NAMPA BUILDING AND SITE DESIGN STANDARDS COMMITTEE

Monday, October 18, 12:30 p.m.

- 1. DR-00187-2021: Building and Site Design Approval for architectural plans related to the new construction of a 13,175 s.f., 16 unit, 2 story apartment building, located in a RP (Residential Professional) Zoning District, at 16548 N Franklin Blvd (R2094800) on a 1.14 acre portion in the NW ¼ of Section 11, T3N, R2W, BM, east of N Franklin Blvd and north of Birch Lane, for Julie Miller, neUdesign Architecture, representing Blake Wolf, Wolf Building Co., Owner.**

2. DR-00189-2021: Building and Site Design Approval for architectural plans related to the new construction of a 14,240 s.f., metal screening wall for R & R Storage, open storage area (Phase 1), located in a BC (Community Business) Zoning District, at 0 Locust Ln, (R2953001000) on a 18.9 acre portion in the NW ¼ of Section 12, T2N, R2W, BM, on the southeast corner of Southside Blvd and E Locust Ln, for Jeff Hatch, Hatch Design Architecture, representing, Linda Claiborne, Owner.

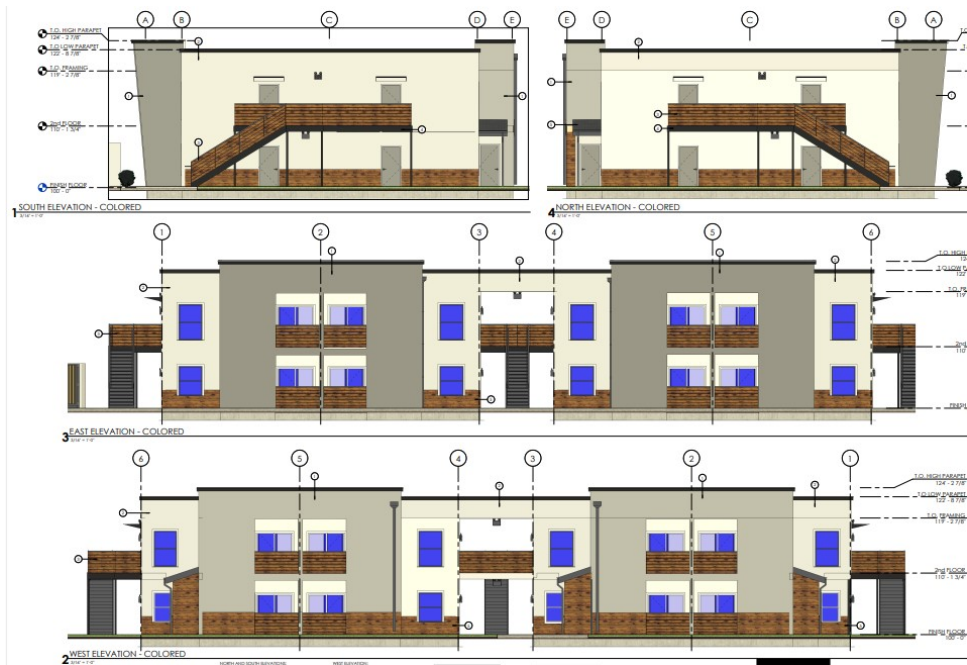
The building is proposed at 24'-3" tall and two stories. The east and west walls are over 100' long and propose jogs, offsets, patios, railings and stairwells. The entry to each building is a stairwell that is covered by the main roof.

One point of ingress/egress from N Franklin Blvd. Mechanical units will be roof mounted and screened by a parapet wall. There are no overhead doors proposed.

There is lighting proposed in the parking area and on the walls of the structure. Height of the poles and on the structure will be a condition of approval with this review.

White or tan vinyl fencing is proposed on the entire perimeter of the site. Trash enclosures will be white or tan vinyl fence to match the new fencing along the perimeter of the site and at the existing dental office.

2. Lighting: On buildings, lighting shall be shielded, screened, or shuttered with ninety degree (90°) cutoff luminaries and shall be directed so as to prevent direct illumination of adjoining properties. Building mounted lights shall not be higher than twenty-five feet (25') from ground level. The height of a freestanding light fixture in the parking lot shall not exceed twenty-five feet (25'). Parking area lights shall use ninety degree (90°) cutoff luminaries. Lighting to highlight or illuminate architecture and signs shall not have significant spillage of light upward or downward. Pedestrian circulation routes shall be illuminated. Floodlights shall not be allowed, except when necessary for security.

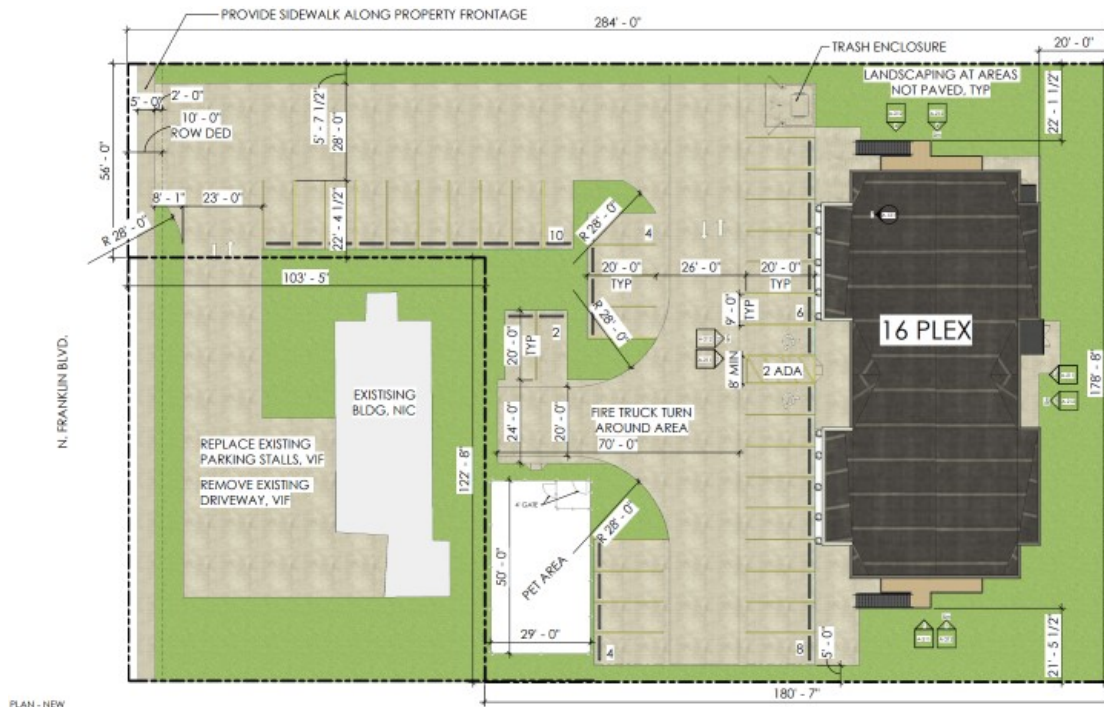
Pedestrian Pathways and Amenities: A dog park/pet area is proposed on the southwest side of the parking area. There does not appear to be any other solid surface connectivity to the ROW aside from the asphalt parking area (most likely there will not be a lot of traffic in that drive isle).

According to the breakdown of materials, all walls appear to meet the requirements for change of materials. These are multi-family structures so the glazing requirement does not apply.

The applicant stated he understood the connectivity to the right of way; a sidewalk will be provided across the frontage. “It is a challenge in these areas where they are surrounded by properties that most likely sidewalks are not going to go anywhere, this one there is a handful (est. 10) properties to the north that are all still County (smaller, half acre single family homes), so I am not sure how important connectivity is from the actual new building to the ROW. We do have a wide drive isle, if you would like, we can designate it with striping.”

Volkert inquired whether handicapped access is required from the street to the building. Applicant responded this would be addressed during site design; codes will be applied by the civil engineer giving exact dimensions and lighting, widths, etc. Watkins stated a solid surface connectivity is required for ADA codes; the Building Dept. will determine whether the drive isle is enough distance behind parked cars to provide that small surface connectivity to the ROW. “That pavement should come out level with those sidewalks the applicant is anticipating putting in and he will have to put curb ramps in at that time. The Building Dept. will determine whether it will be a separate sidewalk path or part of the asphalt.” Applicant stated on a recent project “the connectivity was a striped area from the ROW through the parking lot as a designated area; it didn’t go from asphalt to sidewalk to asphalt, it was striped asphalt.”

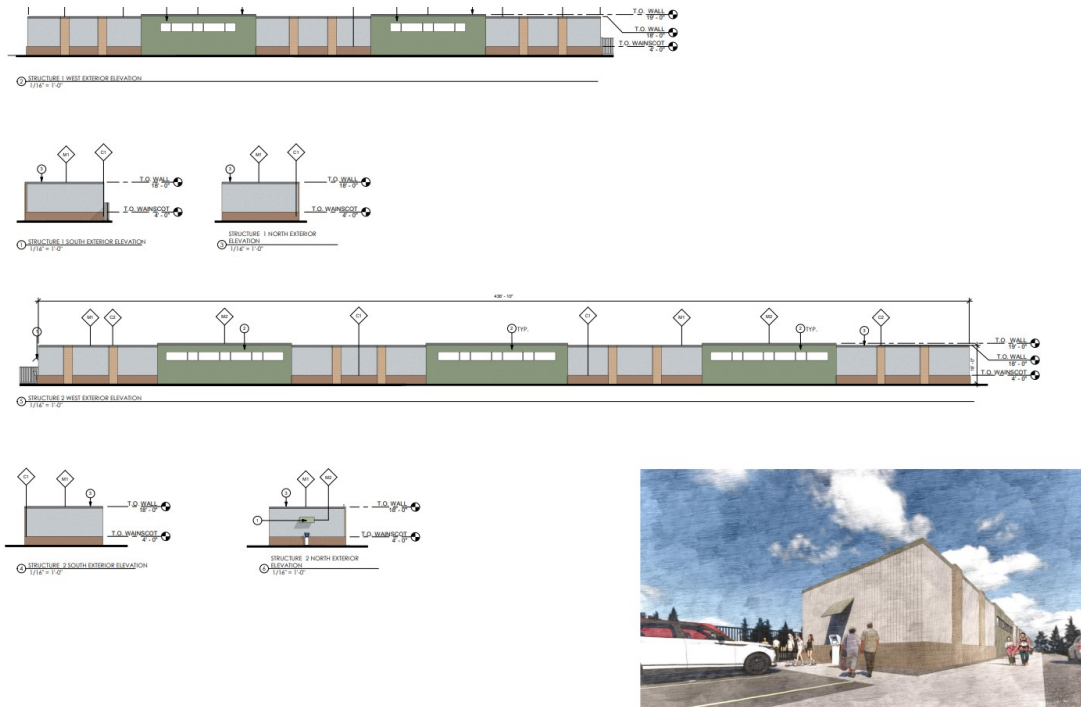
- No roof is proposed at this time. These are walls created to screen the outside storage of RVs and trailers at this time.

The overall height of the wall is noted as 19' to the top of the wall from ground level per submitted application and drawings. One gated entrance from Southside Blvd (automated as there is no office proposed).

- Five (5) colors and three (3) materials are proposed.
- Exterior paint colors shall be earth tone with no white, black or reflective/fluorescent coloring allowed

- Code states “Storage Facility Offices” – the following calculations are for the entire wall face as this project does not propose an office area at this time.
 - The primary façade is the west façade which proposes 5% opening on structure #1 and 7.5% opening on structure #2.

Lighting was not submitted with this application; lighting will be reviewed at the time of building permit and added here as a condition.

Wrought iron and chain link fencing are proposed to secure the site. Some of the future fenced areas might become part of the interior of the project when future phases develop, so they have proposed wrought iron and chain link fencing just to secure the site at this time.

Chairman Veloz inquired about the screening across from the Ridenbaugh canal. Watkins replied the applicant is proposing a chain link fence for security purposes, no screening is required by code. “The whole corner has been annexed and zoned to BC right on the immediate corner where the restaurant is proposed. Currently they are going to put in chain link intermediate fencing; as that develops out it will start to close off that storage area with the other buildings the owner is proposing.” The buildings will back up to that property and create their own screening.

2. All exterior structure lighting shall be shielded, screened, and/or shuttered from with ninety degree (90°) cutoff luminaries and shall be otherwise directed so as to prevent illumination of adjoining properties, particularly when located adjoining or across the street from residentially used or zoned properties.

3. Pole lights shall be limited to two (2) light poles per one hundred feet (100') of service drive and shall not exceed twelve feet (12') in height. Such lights shall also use ninety degree (90°) cutoff luminaries ("downlighting").
